Project:
Goodyear Total Tyres
Warehouse Facility
Site Address:
LOT 205 on SP2955994

LANDSCAPE PLANS APPROVED

Application No.: **OPW/2022/1618**

Landscape Operational Works SPECIFICATION & PLANTING SCHEDULE

Drawing No: 6098-L-PR1-PP02
Rev. No: D

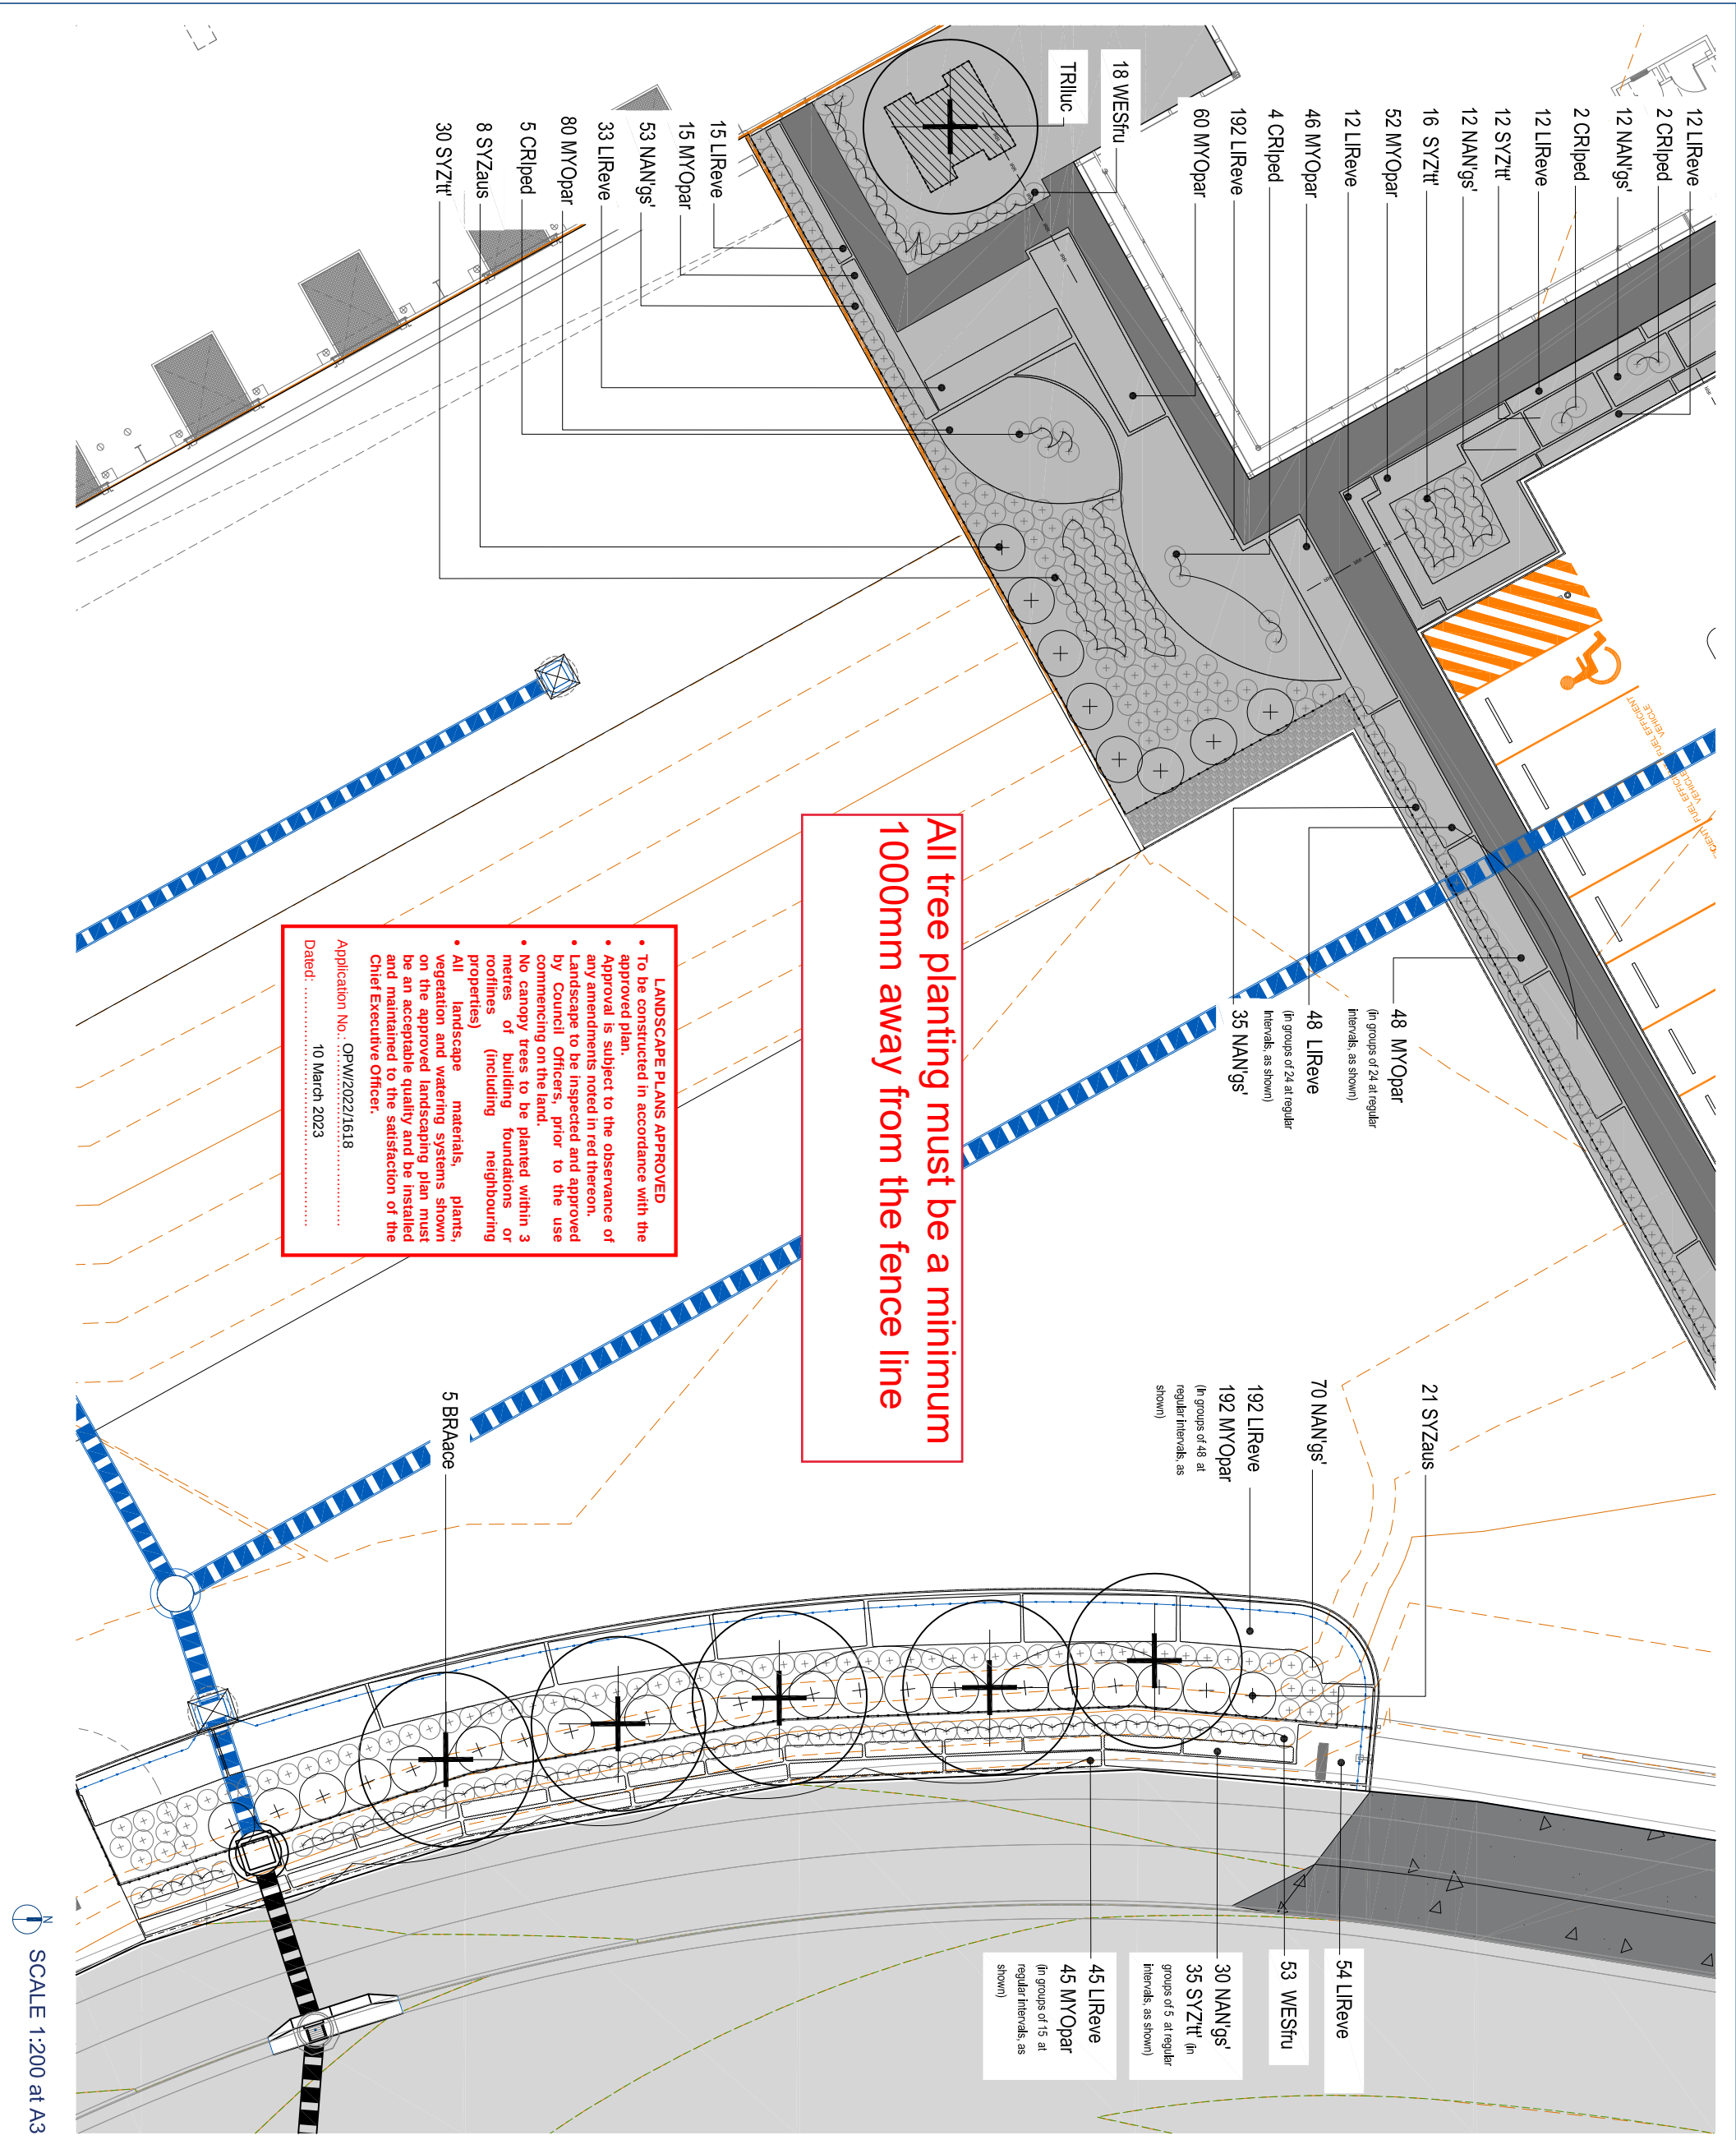
All tree planting must be a minimum 1000mm away from fence line.

Drawing No: 6098-L-PR1-PP07 Rev. No: D

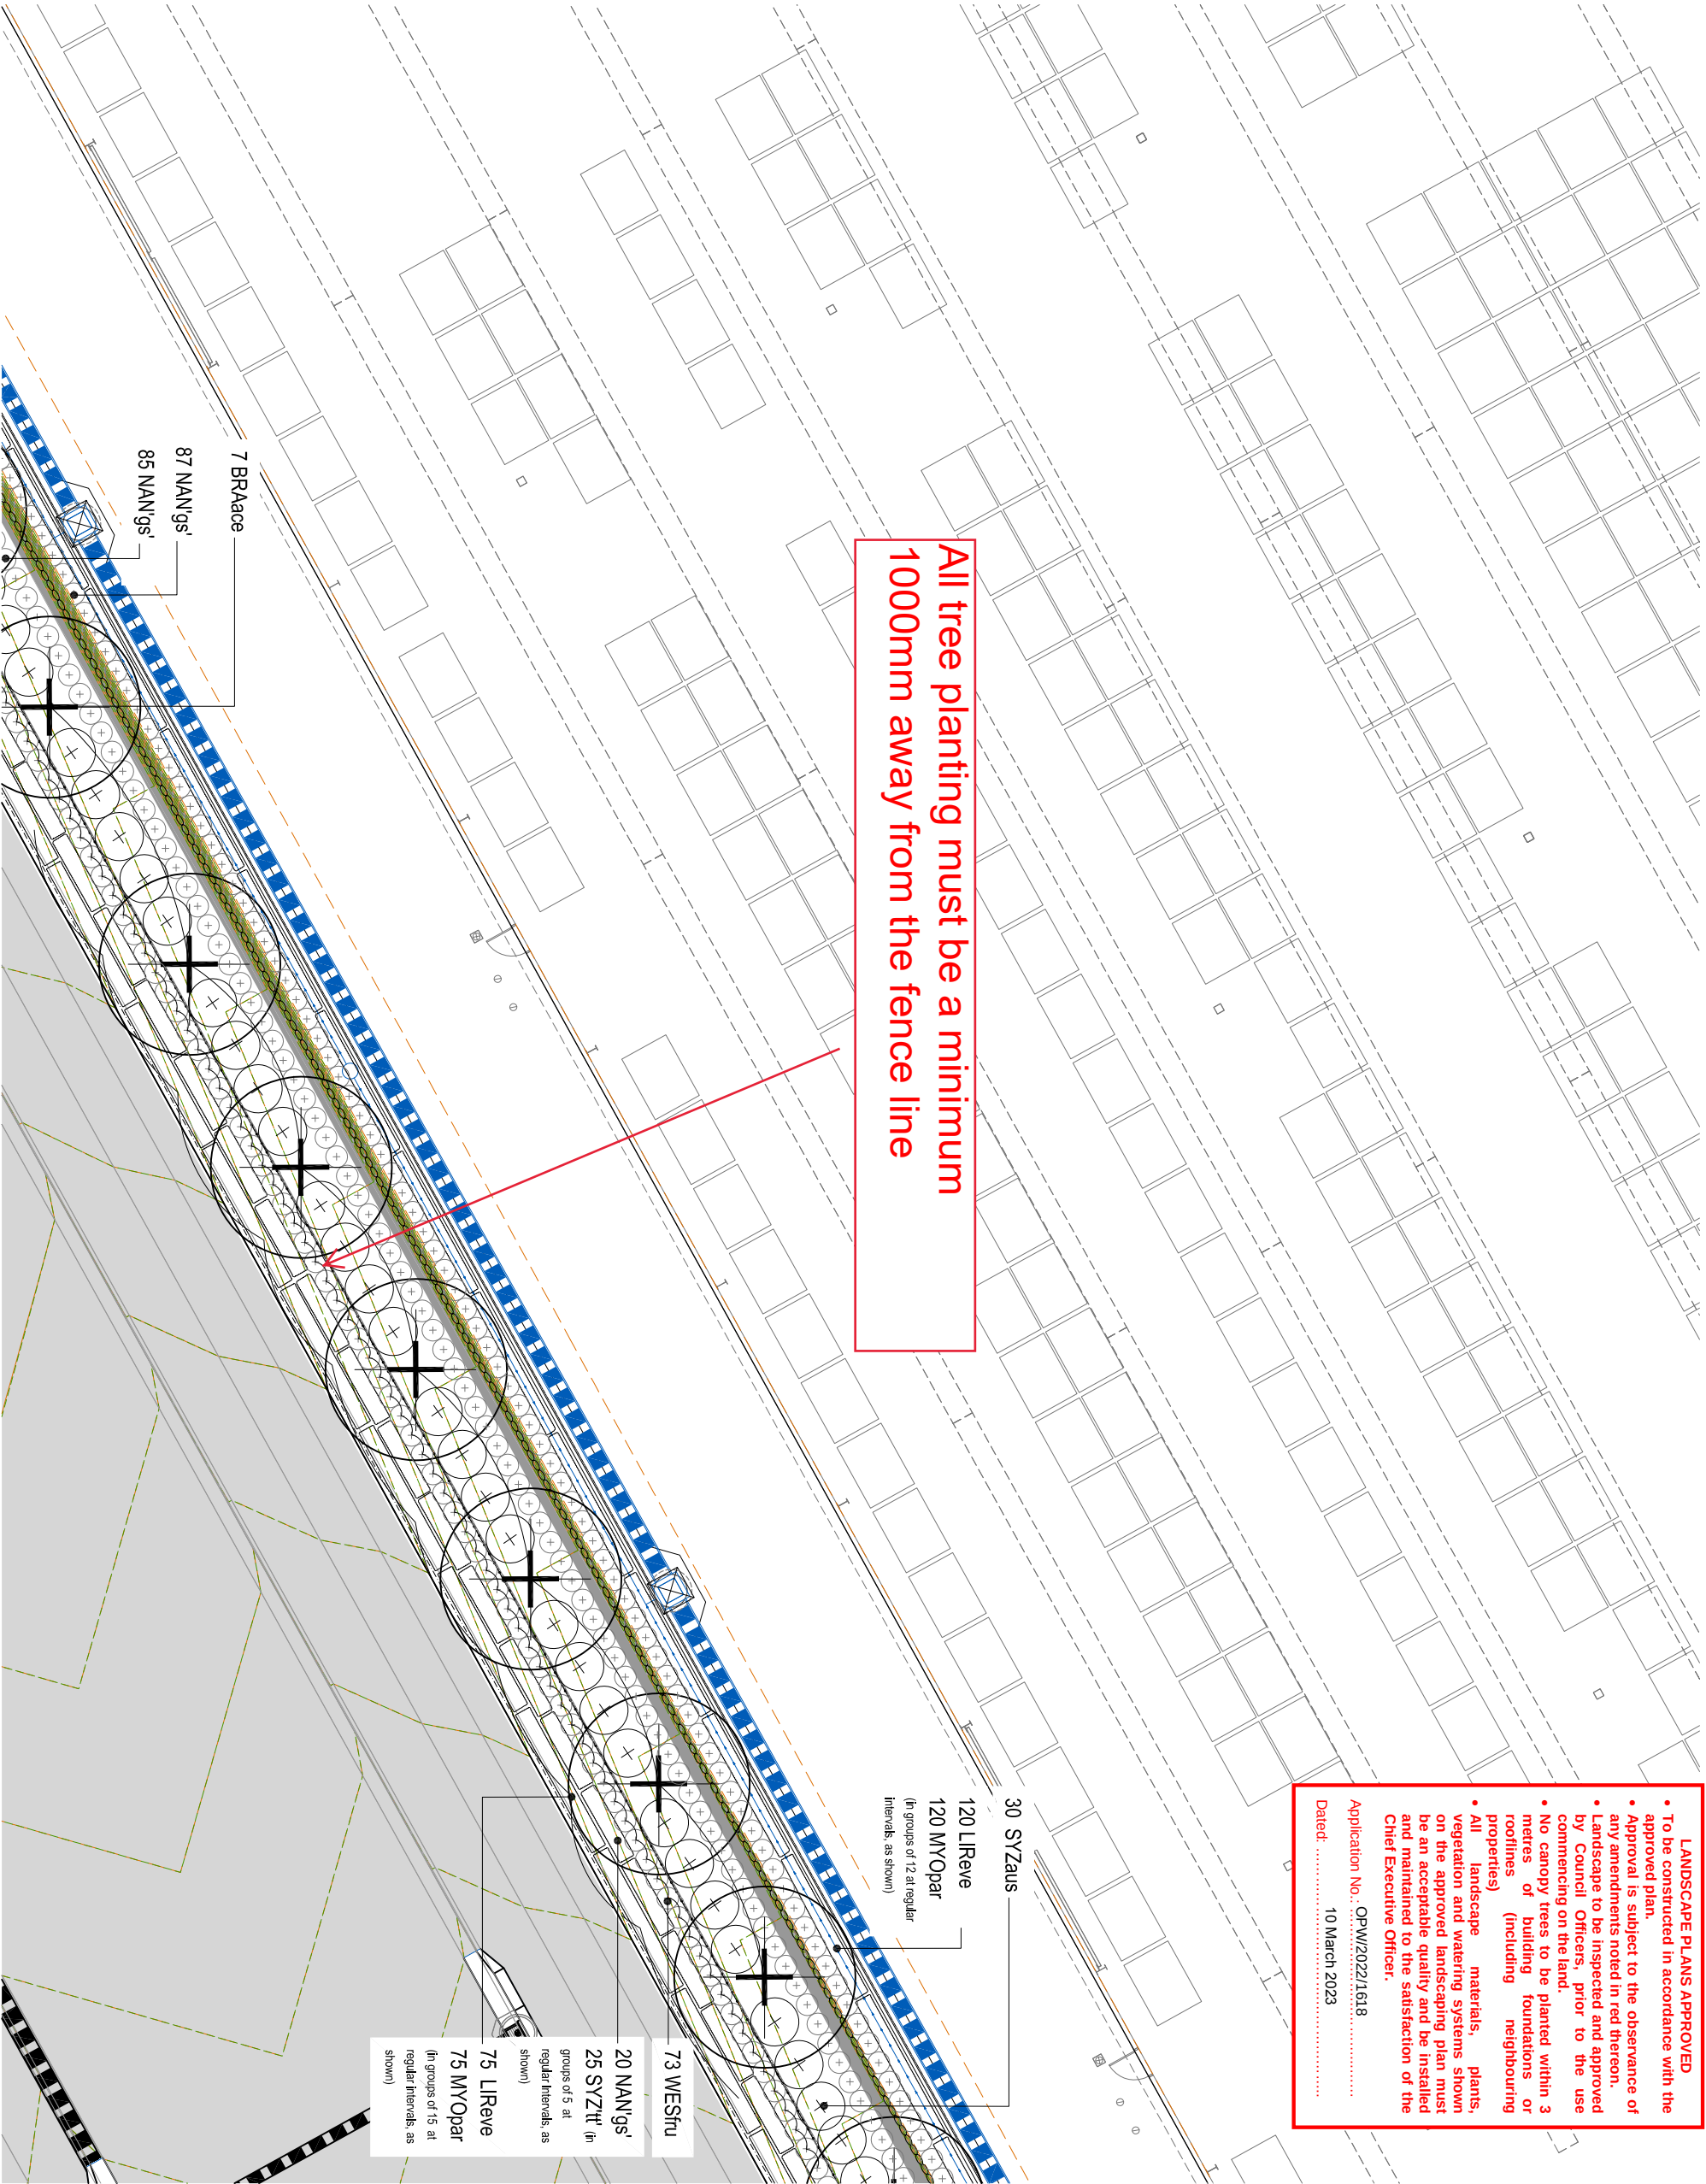
30 SYZaus
120 LReve
120 MYOpap
(in groups of 12 at regular
Intervals, as shown)

73 WESTfu
20 NAN'gs'
25 SYZ'tt' (in
groups of 5 at
regular intervals, as
shown)
75 LReve
75 MYOpap
(in groups of 15 at
regular intervals, as
shown)

All tree planting must be a minimum
1000mm away from the fence line

Drawing No: 6098-L-PR1-PP08 Rev. No: D

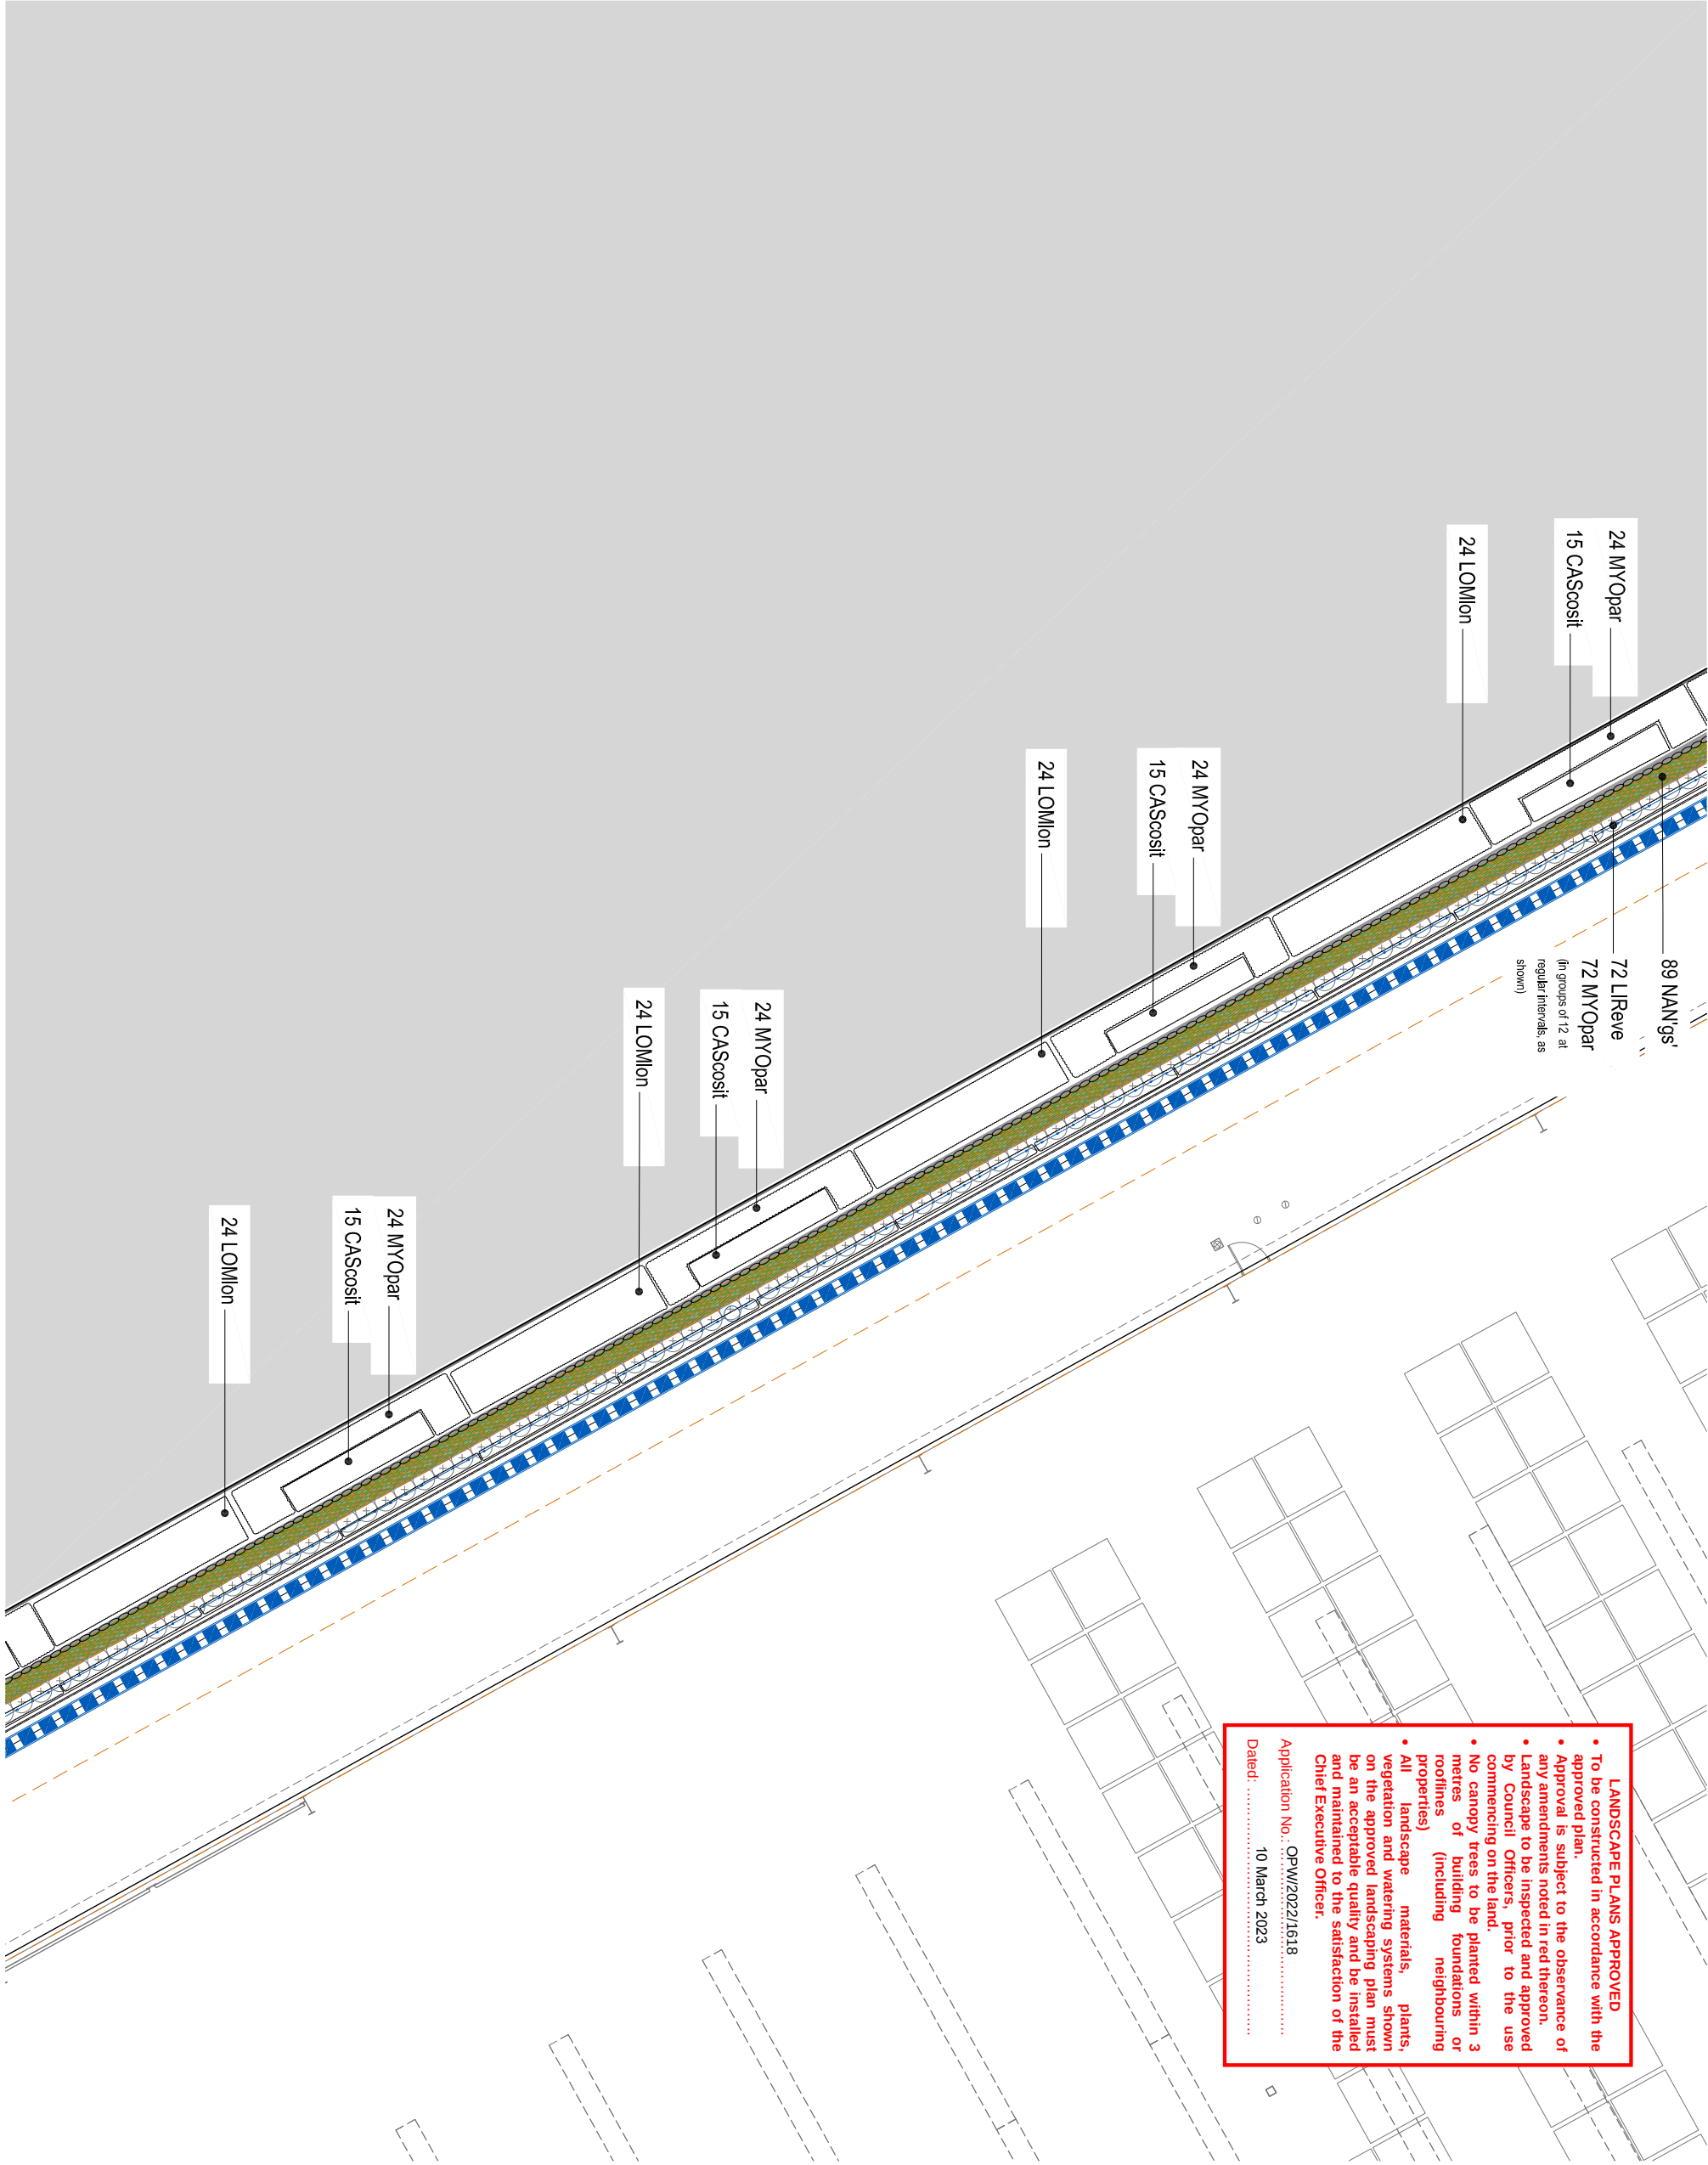
All tree planting must be a minimum 1000mm away from the fence line

72 LIRave
84 MYOpar
(In groups of 12 at regular intervals, as shown)

55 NAN'gs'
55 SYZ'it' (In groups of 5 at regular intervals, as shown)
90 LIRave
75 MYOpar
(In groups of 15 at regular intervals, as shown)

24 MYOpar
15 CAScosit
7 BRAce
74 NAN'gs'
29 SYZaus
79 WESTfu

95 NAN'gs'
24 LOMlon
